Access Compliance Report

Public Rights-of-Way

Intersection ID: 44555	Main Street: UNIVERSITY_CITY_BV	Cross Street: N_TRYON_ST	Location: NW
ADA ID: 7B5C3D9D9C53	Ramp Type: Perp	Initial Pass/Fail: Pass	Overall Compliance: No
Severity Score: 20			
Codes/Mitigation Info/Possible Solution		Field Measurements/Component Compliance

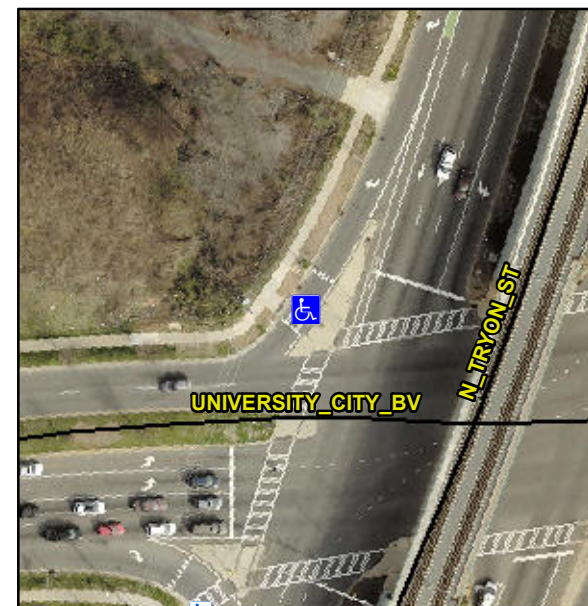
Compliance	Description	Data	Compliance	Description	Data
N/A	Ramp Length (in)	88.0	Yes	Ramp Slope (%)	7.4
Yes	Ramp Width (in)	94.0	Yes	Ramp XSlope (%)	0.2
No	Flare Type	Curbed_WithWalkSurface	Yes	Flare Type RT	N/A
No	Flare Slope LT (%)	N/A	N/A	Flare Slope RT (%)	N/A
N/A	Flare Traversable LT?	No	N/A	Flare Traversable RT?	No
Yes	Landing Length (in)	81.0	Yes	DWS Provided?	Yes
Yes	Landing Width (in)	94.0	Yes	DWS Contrast?	Yes
No	Landing Slope (%)	4.1	Yes	DWS Length (in)	24.0
Yes	Landing X Slope (%)	0.6	Yes	DWS Full Width?	Yes
N/A	Landing Curb? (Y/N)	No	Yes	DWS Offset (in)	0.0
N/A	Shared Landing?	No			
No	Gutter Ponding?	Yes	Yes	Gutter Slope (%)	1.6
No	Gutter Lip Ht (in)	1.0	Yes	Gutter X Slope (%)	0.3
N/A	Painted X Walk1?	Yes	N/A	Painted X Walk2?	N/A
	X Walk 1 Direction	To SE		X Walk 2 Direction	N/A
N/A	X Walk 1 Width (in)	120.5	N/A	X Walk 2 Width (in)	N/A
	X Walk 1 Slope (%)	0.9		X Walk 2 Slope (%)	N/A
	X Walk 1 X Slope (%)	0.0		X Walk 2 X Slope (%)	N/A

Yes	Ramp inside XWalk1?	Yes	N/A	Ramp inside XWalk2?	N/A
	Road Slope (%)	N/A	N/A	Clear Space?	Yes
	Road X Slope (%)	N/A	N/A	Clear Space to XWalk (in)	N/A
Yes	Any Obstructions?	No	Yes	Storm Grate/Utility Hazard?	No
	Obstruction Type			Storm Grate/Utility Type	
		N/A			N/A
			Yes	Surface Condition? (G/P)	Good

**Remove & Replace Entire Ramp.
Grind Gutter Lip.**
